NOTICE OF MEETING
PLANNING AND ZONING COMMISSION
6:00 P.M. – July 14, 2022

MEETING AGENDA

PLANNING AND ZONING COMMISSION ITEM:
PC-22-17

PLANNING AND ZONING COMMISSION ITEM:
PC-22-18

MDS LAND SURVEYING COMPANY, INC.
 ALTA | BOUNDARY | CONSTRUCTION | OIL & GAS | TOPOGRAPHIC
 TEXAS BOARD OF PROFESSIONAL LAND SURVEYING FIRM REGISTRATION NO. 10019600
 874 HARPER RD, SUITE 104 • KERRVILLE, TX 78028 • 830-816-1818
 JOB No. 22-100-00 SURVEYORS: JB/DB SHEET 1 OF 1

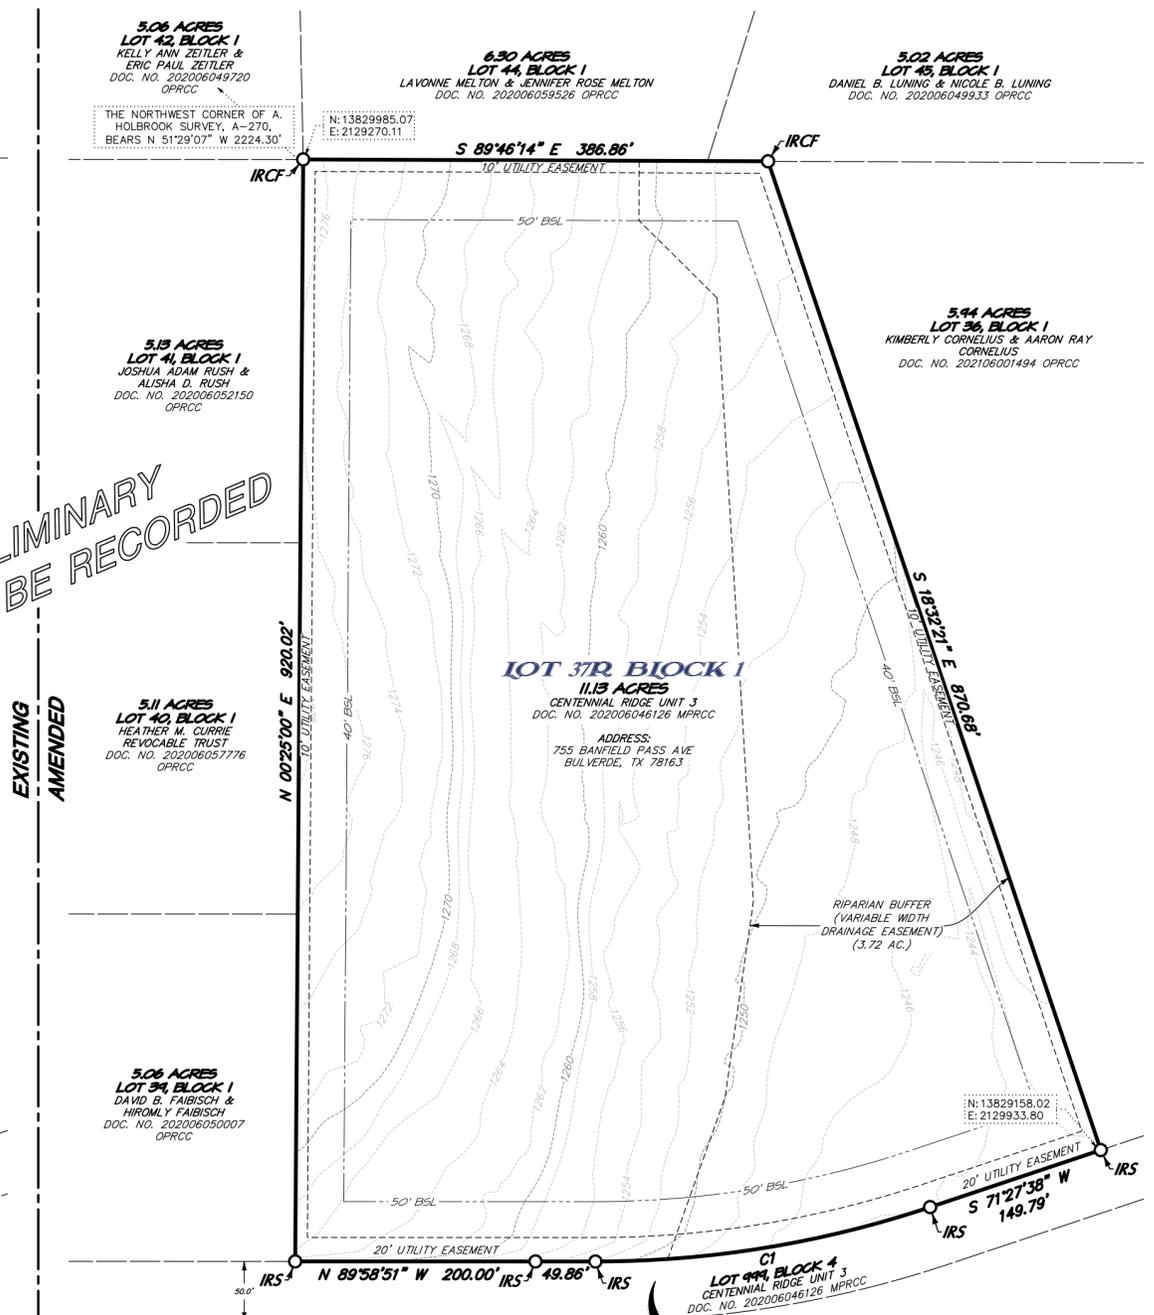
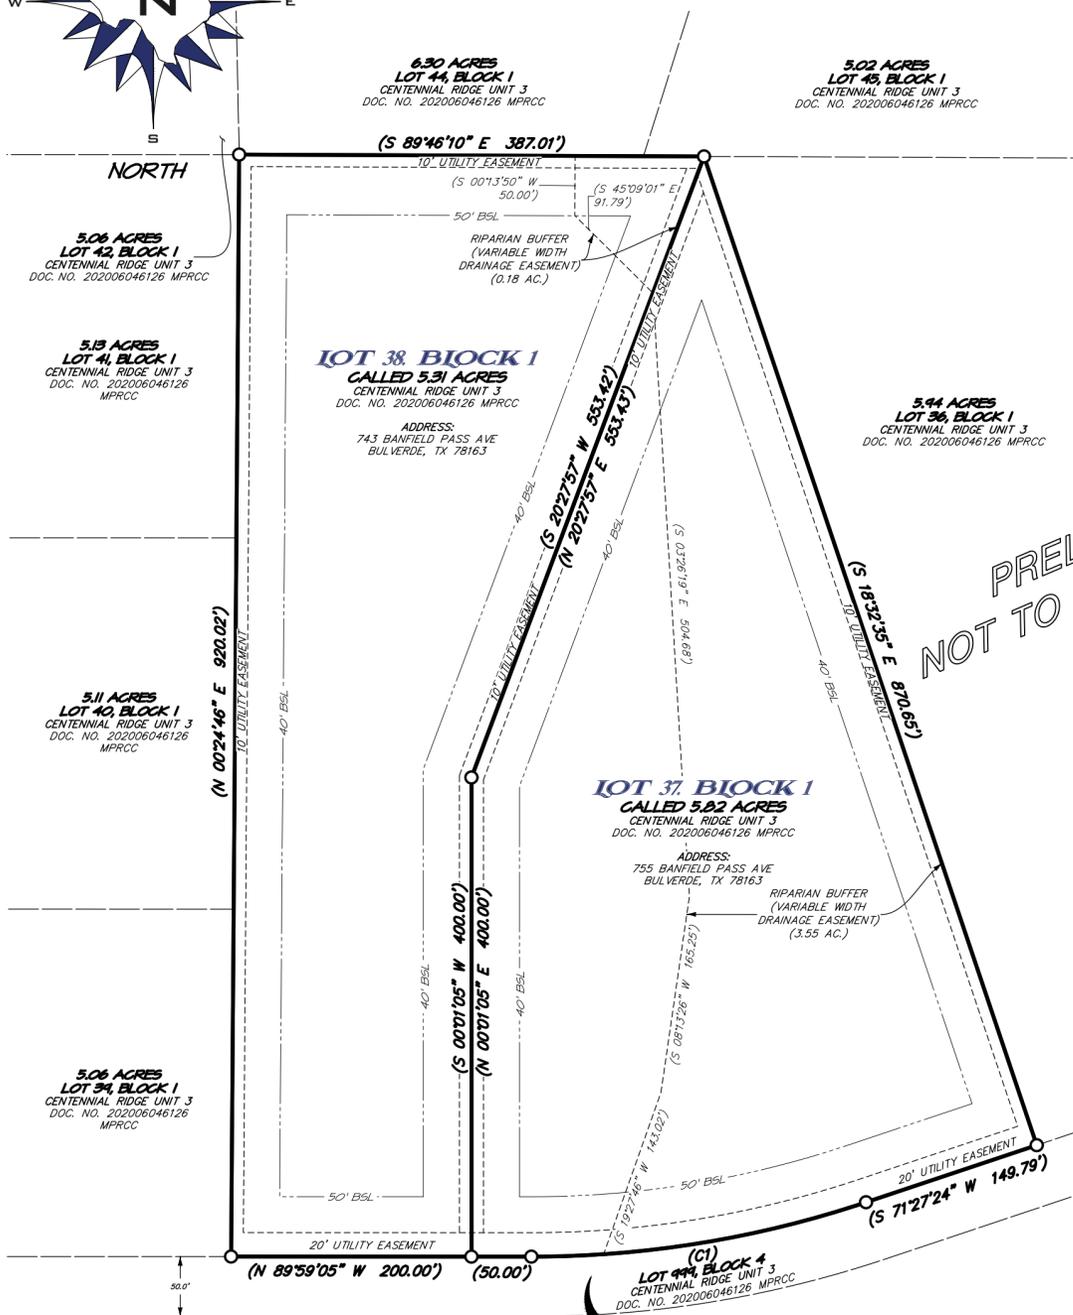
1. Revise the title of the plat from “amending” to “replat” and remove Table of Amendments. – [Comment Resolved](#)
2. Remove Staff Approval block and add Planning & Zoning and Planning Director blocks as stated below with the title of the plat document filled in and underlined. – [Comment Resolved](#)

3. Add Lienholder address and certification to plat in addition to owner address and certification [Section 1.05(b)(5) and 1.05(b)(6)]. – [Comment Resolved](#)
4. Adjoining owner information should include acreage [Section 1.05(b)(21)]. – [Comment Resolved](#)

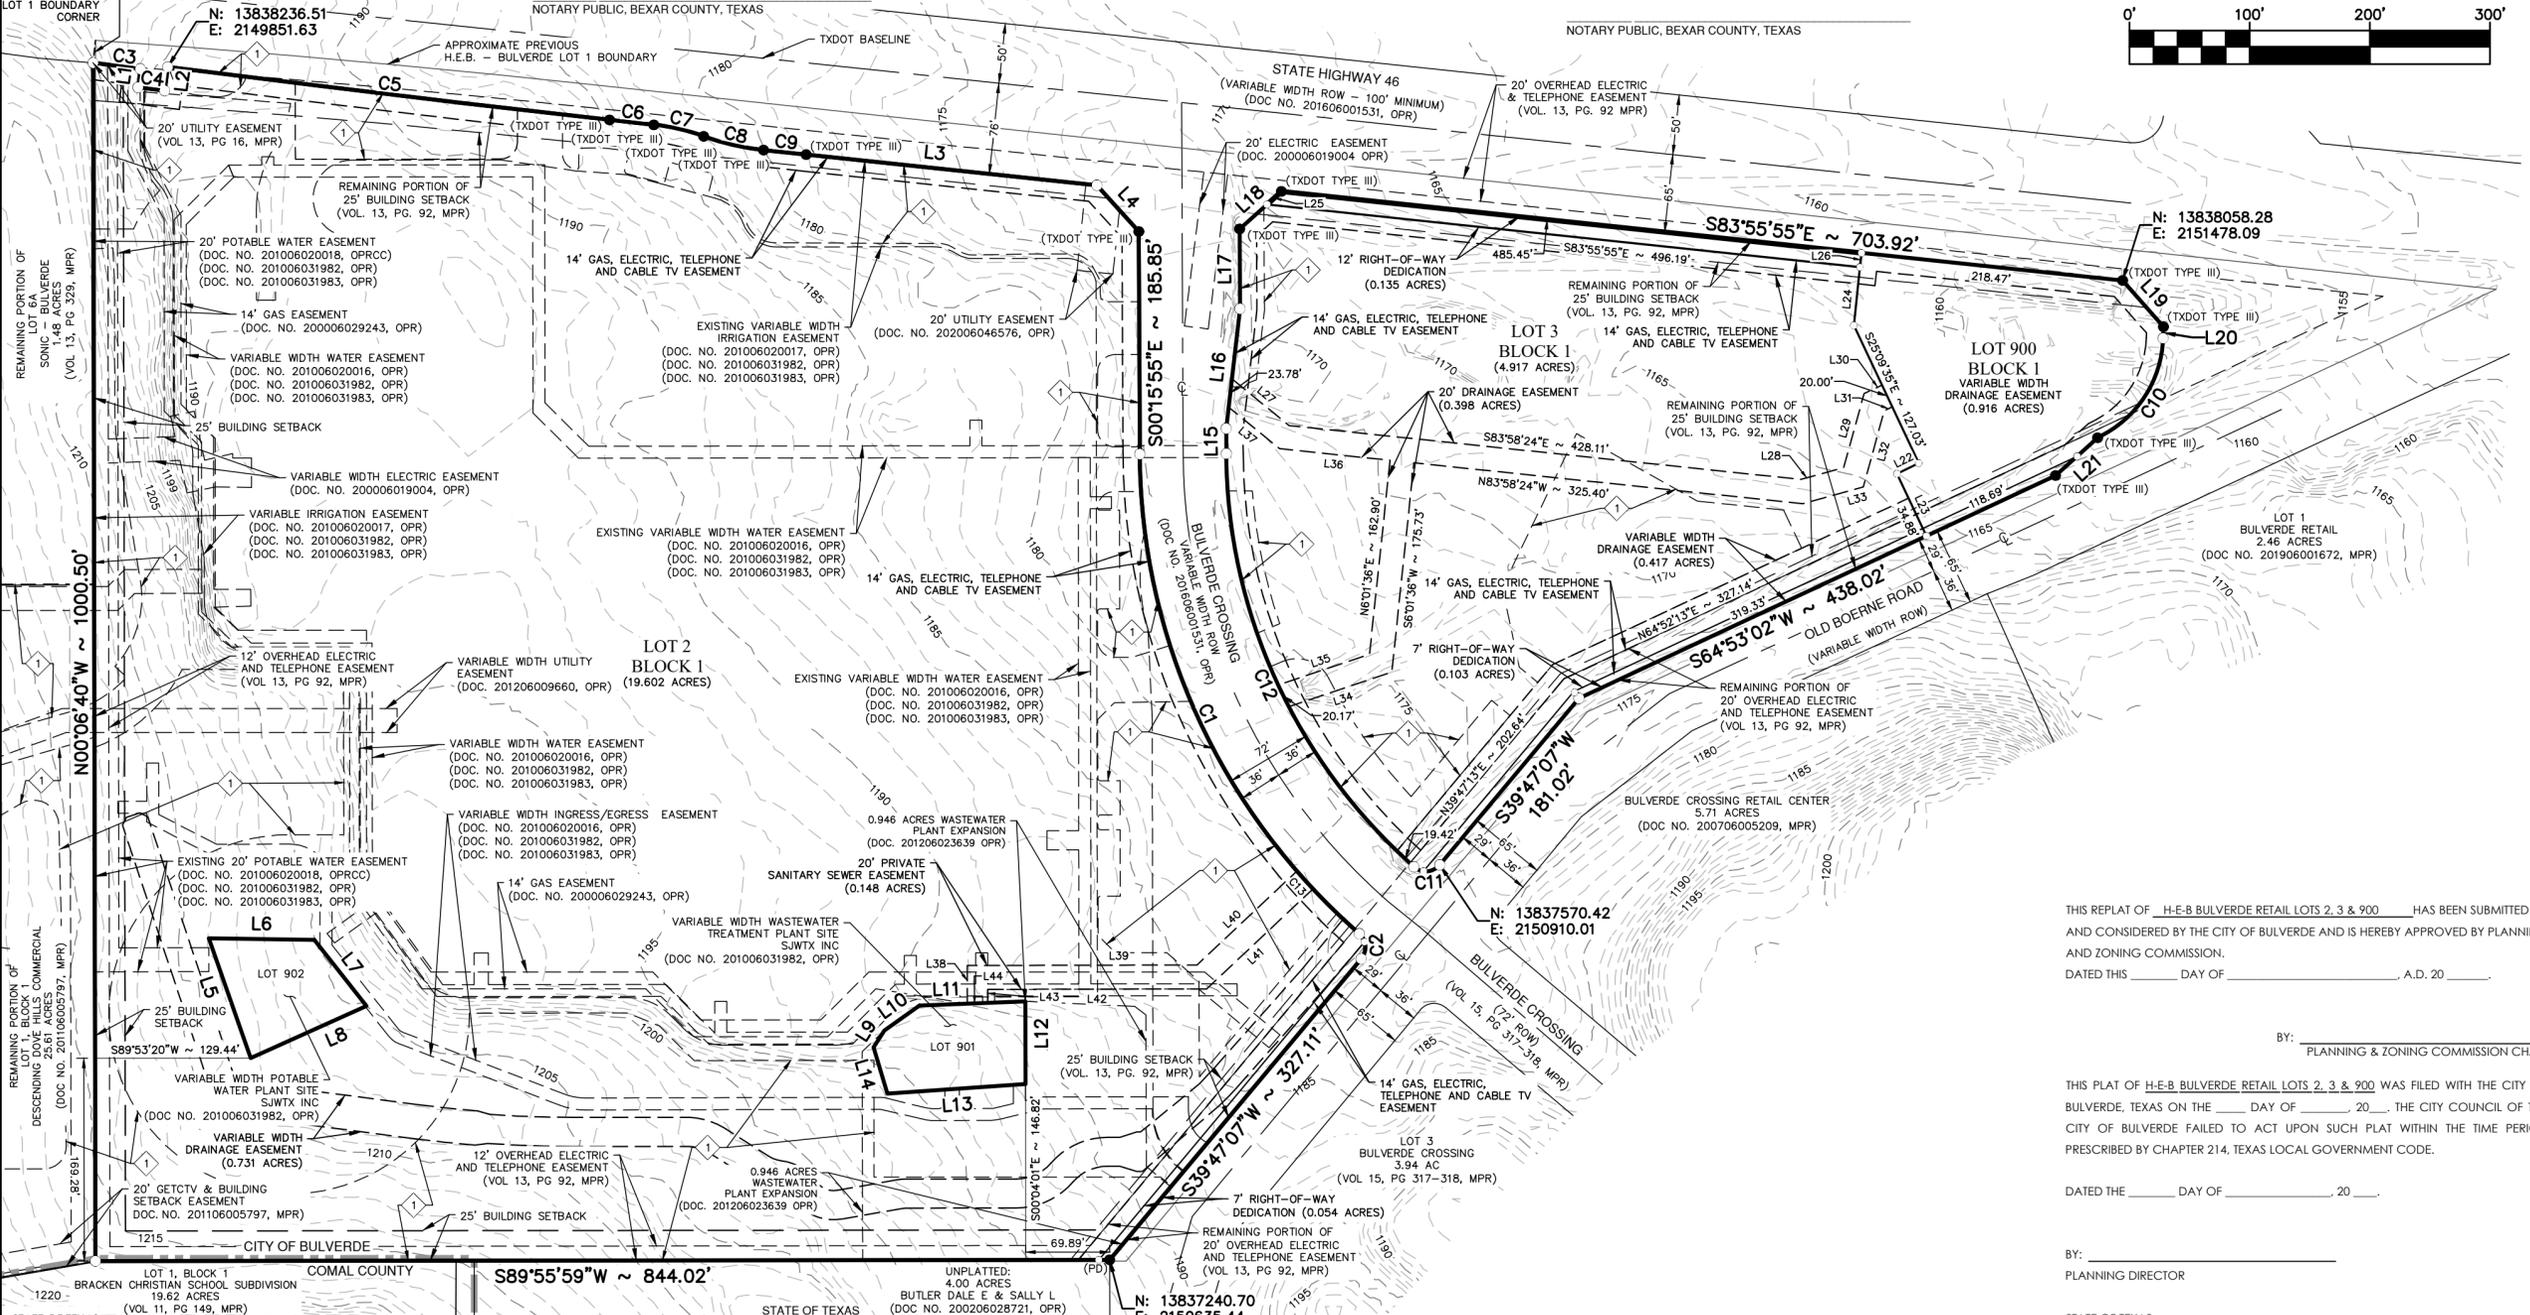
1. Add owner/notary blocks for SJWTX, Inc, as an owner or property within the subdivision [Sec. 1.05(b)(ii)(5)]. [6/27 – Comment resolved.](#)
2. Verify correct county where signature is taking place is used in signature blocks or use a blank “ _____ ” to fill in at the time of signature. [6/27 – Comment resolved.](#)
3. Correct Surveyor signature block with extra “I” at the very beginning. [6/27 – Comment resolved.](#)
4. Remove the “Attest” line on the Planning & Zoning signature block and add the planning director signature block using the wording below: [6/27 – Comment resolved.](#)

5. The City’s Master Thoroughfare Plan indicates Old Boerne Road as a collector requiring 72-ft of right-of-way. Where the existing right-of-way is not sufficient, the subdivision must make a dedication to attain 36-ft of right-of-way on the north side of the centerline or a minimum of 72-ft total width. [6/27 – Comment resolved.](#)

6. A drainage easement should be provided for the open channel across the southern end of Lot 2, conveying off-site water through the subdivision [Sec. 1.05(b)(ii)(10)]. **6/27 – The provided drainage easement should be located by bearings and distances and needs to meet the requirements of Sec. 2.03(d)(iv)(1).**
7. Provide a bearing and distance dimension from a corner of the subdivision to a corner of the original tract or original survey [Sec. 1.05(b)(ii)(14)]. **6/27 – Comment resolved.**
8. Adjoining ownership information should include property acreage [Sec. 1.05(b)(ii)(21)]. **6/27 – Comment resolved.**

18. Drainage Area delineations appear to be appropriate. However, Area C runoff is forced east by a small ditch and through a culvert under Bulverde Crossing. Need to verify 100-YR can be conveyed through this small ditch, through the culvert and be contained within the proposed drainage easement/ditch adjacent to Old Boerne Road to ensure runoff from Area C doesn't spill over into Lot 3 and Lot 900. **6/27 – Comment resolved. Response by Pape-Dawson is sufficient.**

19. Pre-Development HMS model is missing existing detention Basin A. It is assumed the existing basin was designed to mitigate runoff from the existing shopping center on Lot 2. Please include Basin A in the pre-developed model so we can compare with post-development of Lot 3. [6/27 – Comment resolved. Response by Pape-Dawson is sufficient.](#)
20. Please provide HEC-HMS model files. [6/27 – Comment resolved.](#)

SHEET 1
OF 1

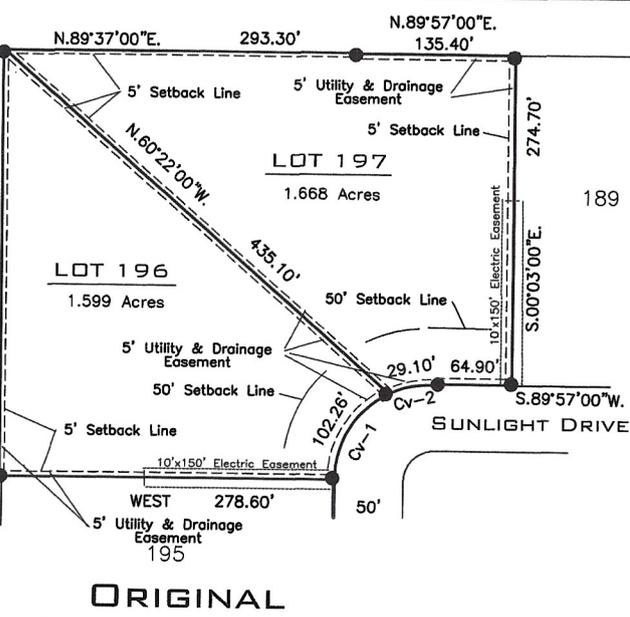
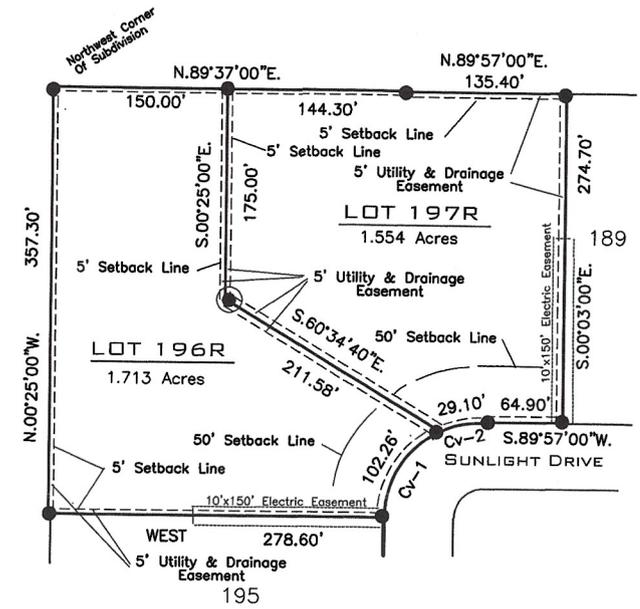
1. Note 2 incorrectly states that the property is located in the ETJ. Please revise to reflect that it is located in the City of Bulverde.
2. Note 10 states that there are no lienholders. Please provide deeds/documentation confirming this.

3. Revise notary block to reflect same spelling of "Steven R. Hunsicker" as noted in the owner's certification.
4. Clarify the title of the subdivision document. "Original and Replat" is appears to be the designated text, but it should be more specific to this document (ex: Vacate and Replat of Lots 196 & 197, Oak Village North, Unit 2)

6. Verify scale of plat document provided. The PDF provided is legal size, and not the 18"x24" required, which may be why the scale/dimensions are not accurate [Sec. 1.05(b)(i) & Sec. 1.05(b)(ii)(3)].

7. The owner's address is required per Sec. 1.05(b)(ii)(6).
8. Provide adjoining information to the proposed plat. Adjoining ownership information shall be shown on the plat drawing that includes: owner name, acreage and deed record information.

10. A minimum of two corners of the subdivision shall be referenced to State Plane Grid Coordinates [Sec. 1.05(b)(ii)(15)].

10. Contour lines missing from plat [Sec. 1.05(b)(ii)(17)]. Include note referencing vertical datum of elevation information [Sec. 1.05(b)(ii)(18)].
11. Show width of Sunlight Drive adjacent to the subdivision, as well as any other lots, easements, or other important features adjacent to the subdivision. Use greyscale dashed lines to indicate features not within the boundary of the subdivision [Sec. 1.05(b)(ii)(20)].

13. Indicate the title as "Vacate and Replat of Lots 196 & 197 of Oak Village North, Unit 2" [Sec. 1.05(b)(ii)(23)].
14. Provide a slope map and any applicable easements as required by Section 1.05(b)(ii)(24) and Section 4.04.

15. Remove the county judge signature block shown and add Planning & Zoning and Planning Director blocks as stated below with the title of the plat document filled in and underlined.

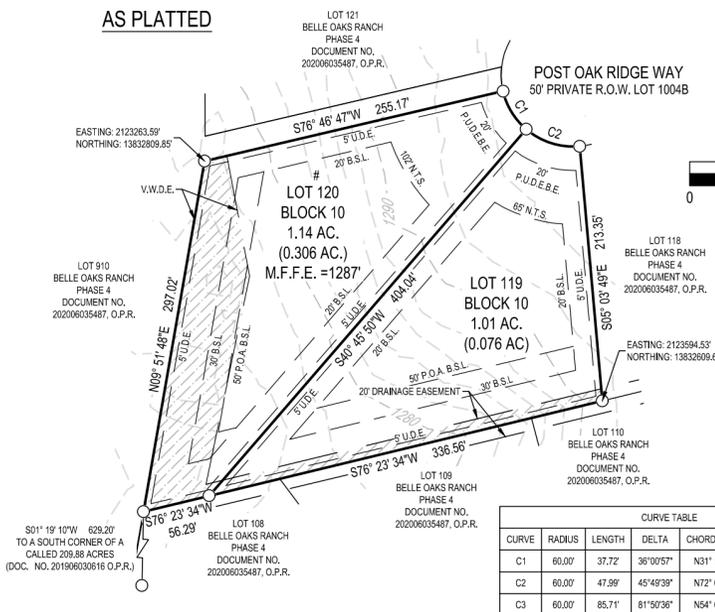
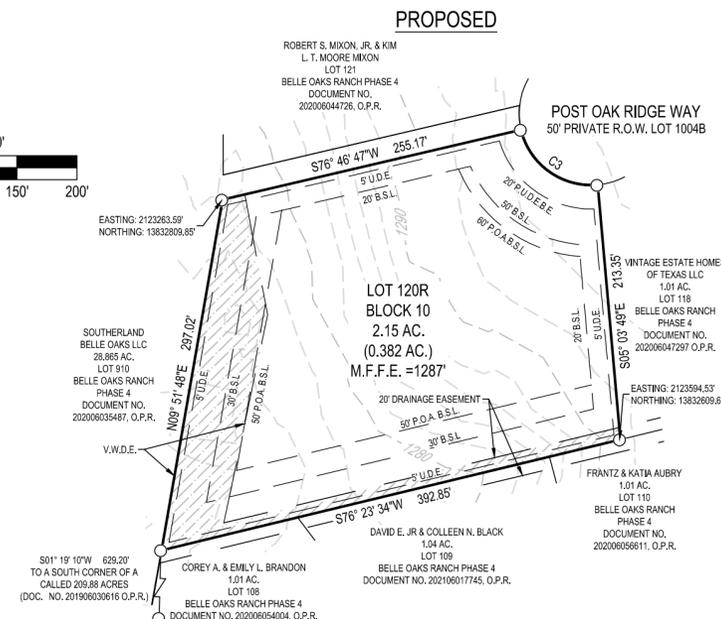
1. Note 1 should not reference an amending plat. – [Comment resolved](#)
2. Appears that Note 22 is unnecessary and should be removed. – [Comment resolved](#)
3. Owner's certification should follow the language from Section 1.05(b)(ii)(9) – ending with ..."hereby dedicate to the use of the public forever all streets, parks, water courses, drains, easements, and public places thereon shown for the purposes and considerations therein expressed." – [Comment resolved](#)
4. Adjoining lot information should include owner name, acreage and deed record information, as specified in Section 1.05(b)(ii)(21). – [Comment resolved](#)
